**RE: Sheetz – Elizabethtown, PA (Veterans Drive)
Final Land Development Plan
Mount Joy Township
RGS Project No: 2024A84-019**

**RE: Sheetz – Elizabethtown, PA (Veterans Drive)
Modification Request
Mount Joy Township
RGS Project No: 2024A84-019**

Re: Final Land Development Plan for Sheetz-Elizabethtown PA (Veterans Drive)
Our File No. 10221-1

Re: Sheetz – Elizabethtown, PA (Veterans Drive)
Final Land Development Plan
Township Permit No. 24-22-FLDP
LCEC Project No: 25-169

PROJECT NAME:
SHEETZ
 ELIZABETHTOWN, PA
 DRAWING NUMBER:
RL-9804-S1-R1

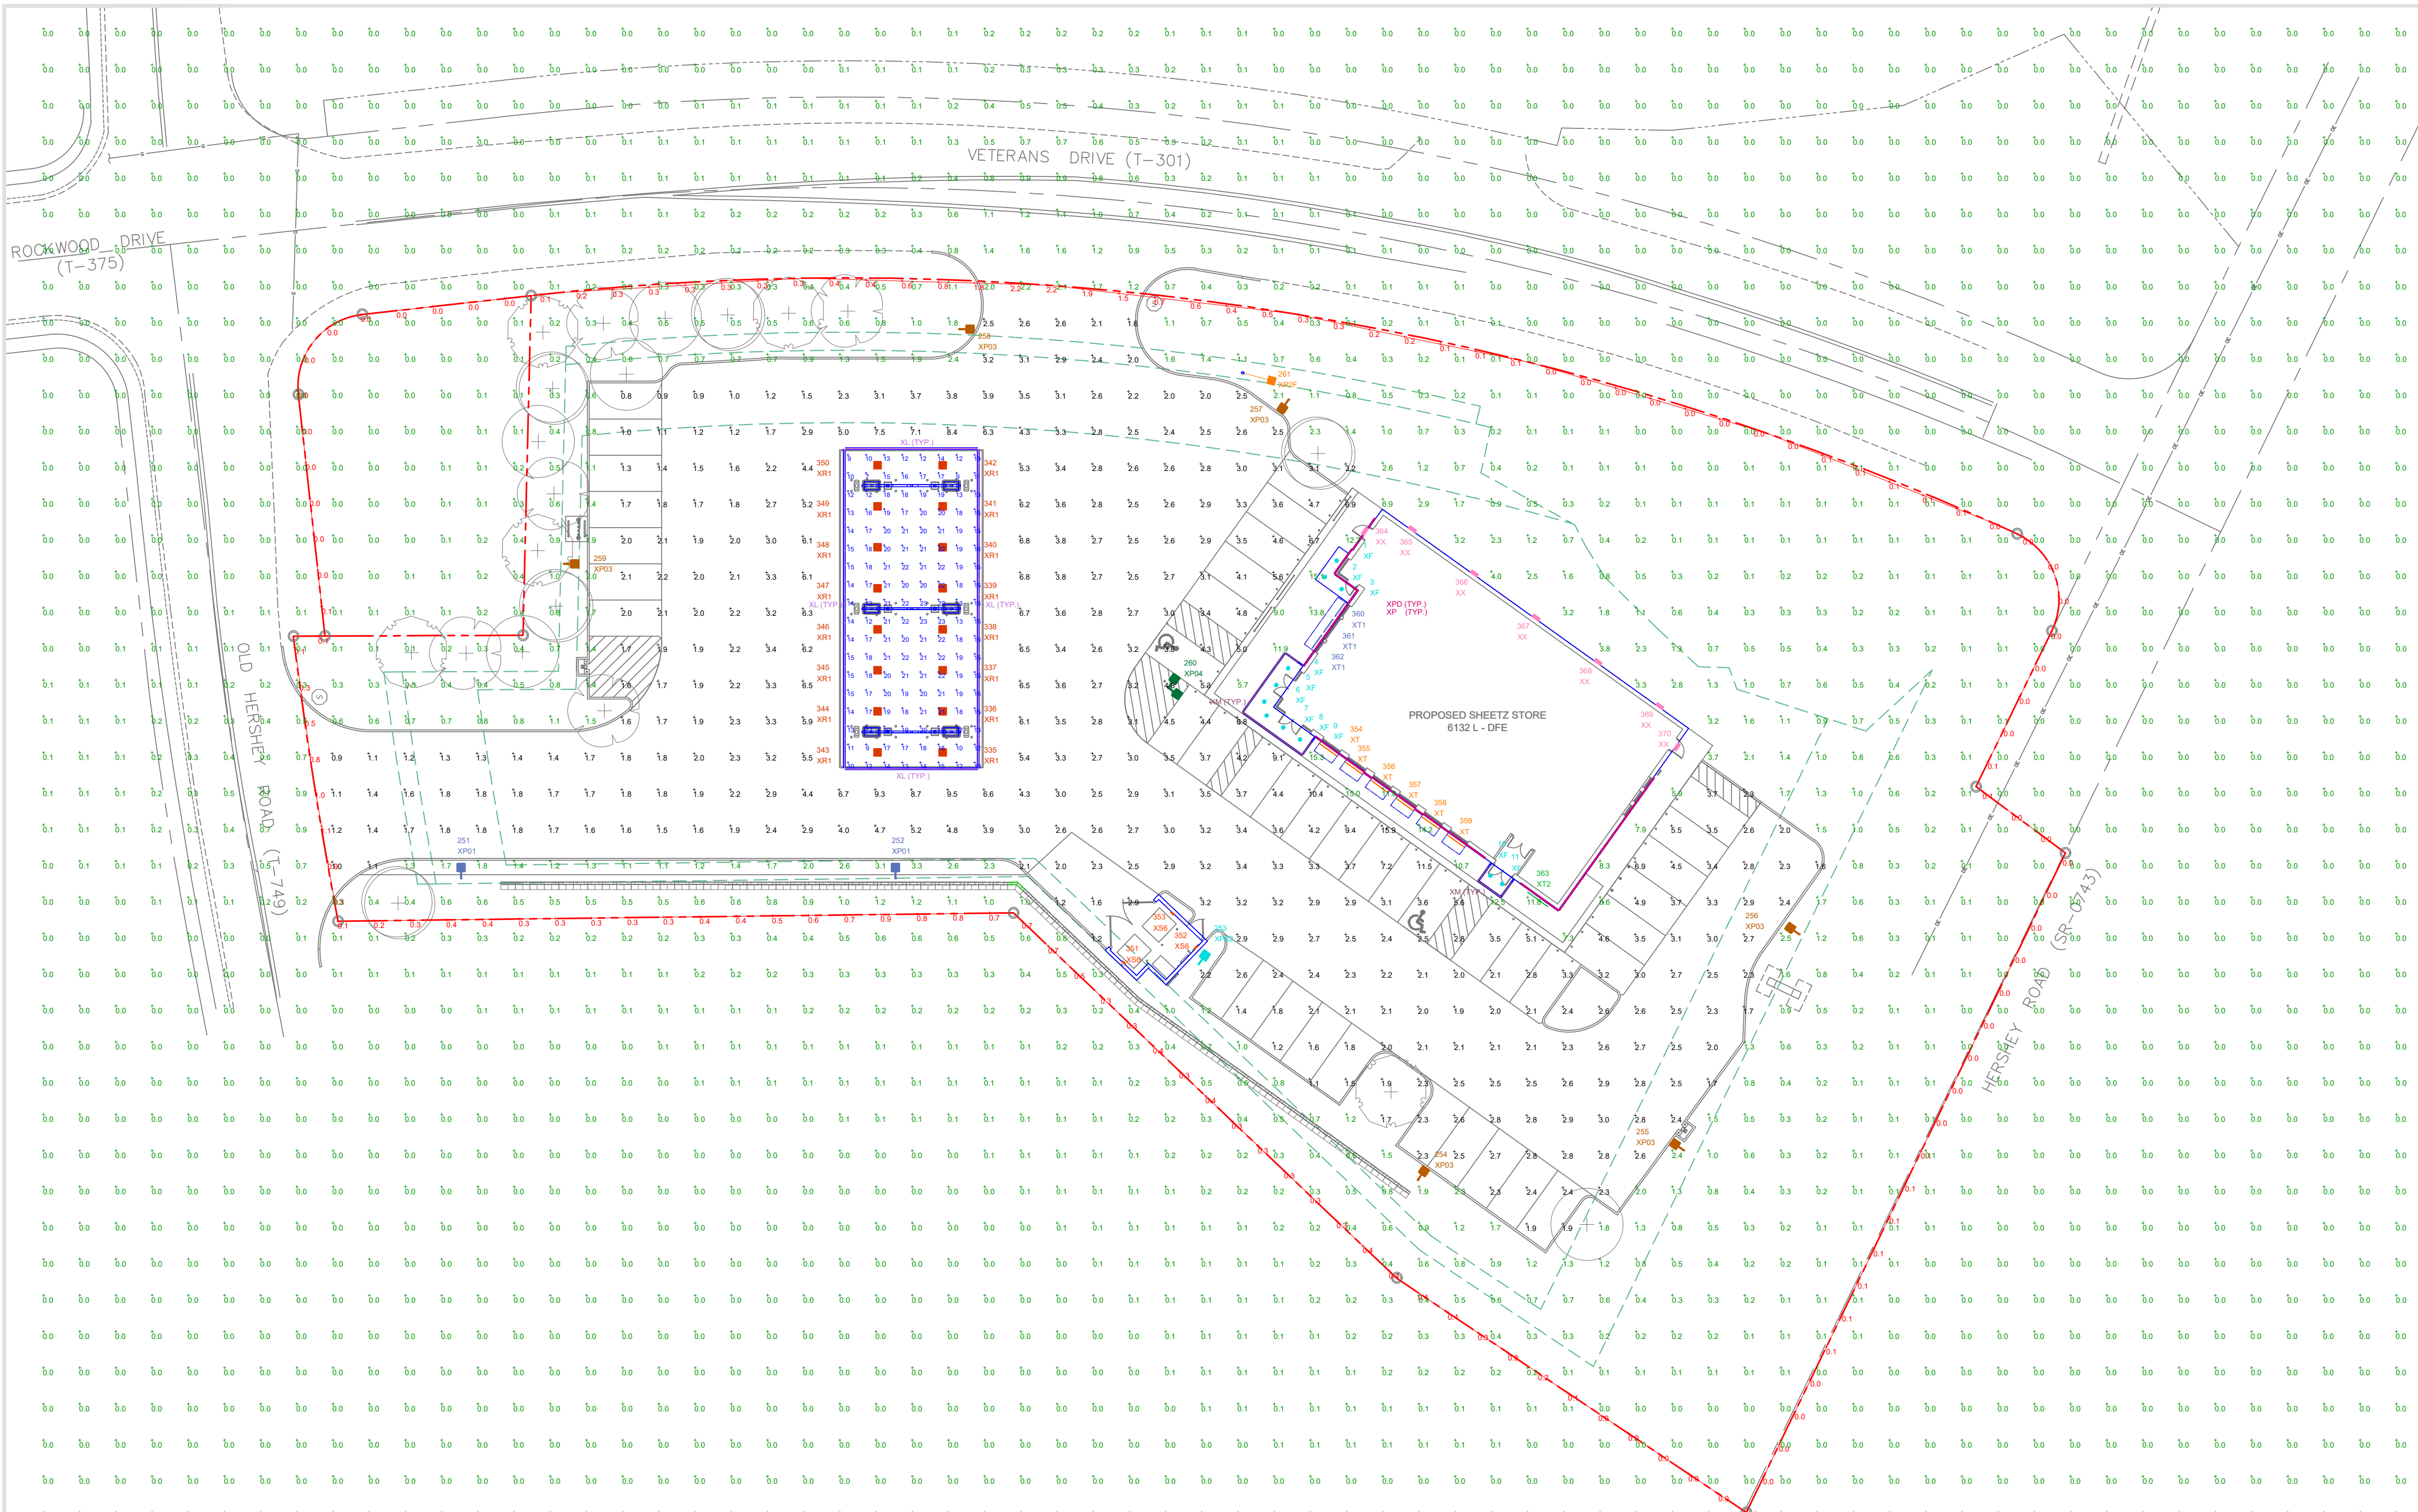
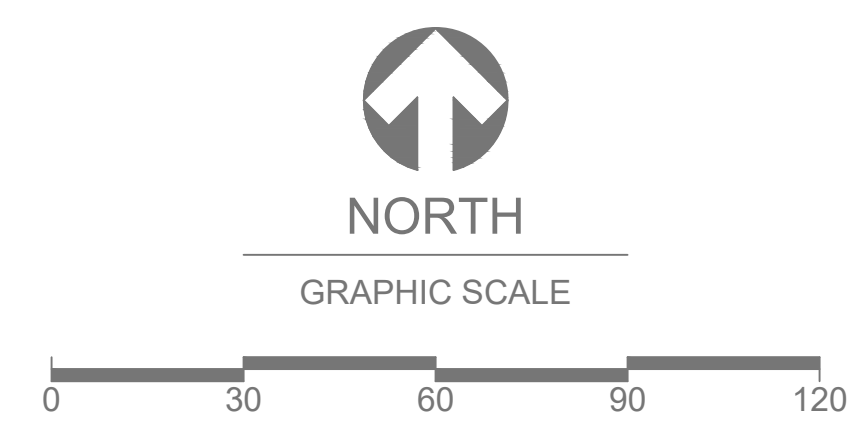
3. A note shall be added to the plans that all applicable permits shall be obtained for the underground storage of fuel (135-268.K).
4. Flag lighting sources shall not exceed 10,000 lumens (135-298.C(13)).

5. The maximum permitted illumination projected away from any use onto a residential use shall at no time exceed 0.1 footcandle, measured line-of-sight from any point on the receiving property (135-298.C(16)(a)).
